City of Santa Fe, New Mexico

memo

2025-011228-HDRB, 927 Canyon Rd., Downtown & Eastside Historic District, non-contributing, Innovative Design Construction, agent for Joseph Gonzalez, owner, proposes to construct a 576 sq. ft. carport addition to a height of 10'-0" where the maximum allowable is 18'-1".

Figure 4: Carport Design

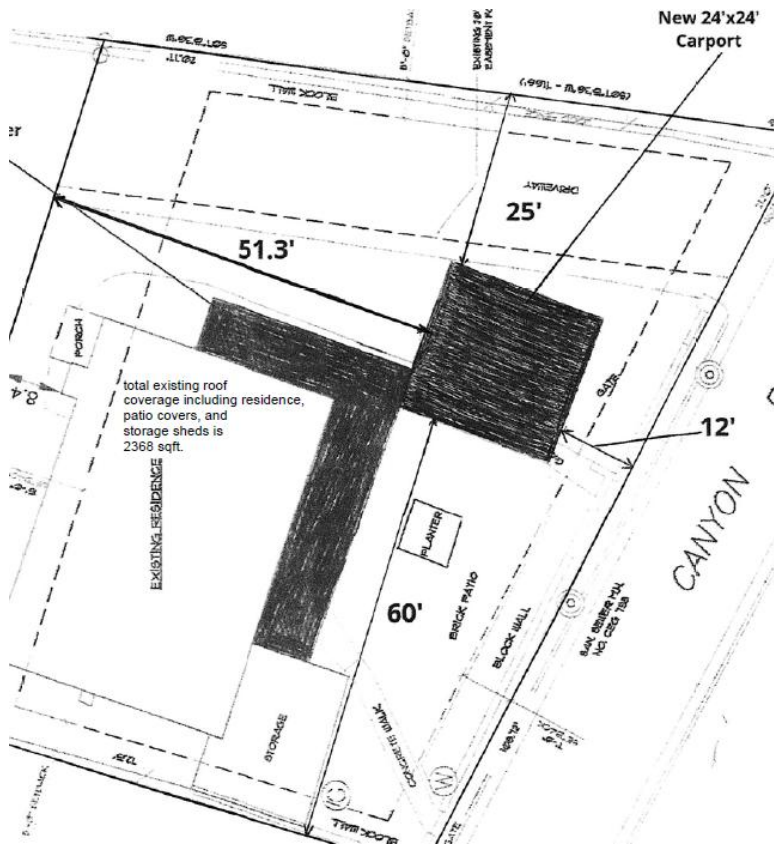
The applicant came before the board on October 28, 2025, and the decision of the Board was to postpone the case for a redesign that takes into consideration the character of the streetscape and the prominent placement of the publicly visible structure. They also recommended that the applicant meet with the building division to make sure that the design will meet the engineering requirements, meet with the Terrain Management team to ensure that the slope of the roof meets

the drainage requirements, and see if any ponding is required for the additional roof coverage. The applicant is currently discussing the design with both the Terrain Management team and the Building Division. The applicant has submitted a new design as recommended by the Board.

Staff recommends approval of the proposed project and finds that the application complies with Section 14-5.2(D) General Design Standards for all Historic Districts, and 14-5.2(E) Downtown and Eastside Design Standards.
